NUMBER: SB 550-54-001, Rev A  
MODEL: ECLIPSE EA550  
SUBJECT: Right Pylon Inspection and Repair

This Service Bulletin provides instructions to inspect and repair structure where the right pylon frame attaches to the fuselage.

**Figure 1. Area of Inspection**

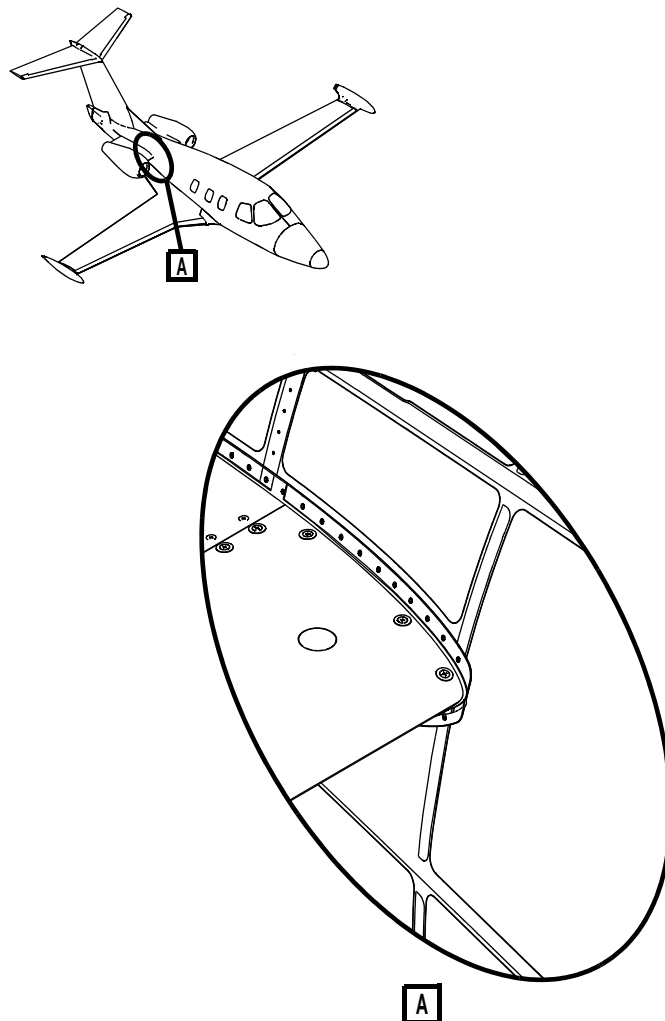
- (1) Inspect the area where the Frame, Pylon, Aft Fuselage, RH (p/n 53-114187) attaches to the aft fuselage for damaged rivets. Refer to [Figure 1](#), [Figure 2](#), and [Figure 3](#).
  - (a) If damage is noted, proceed to the Repair section.
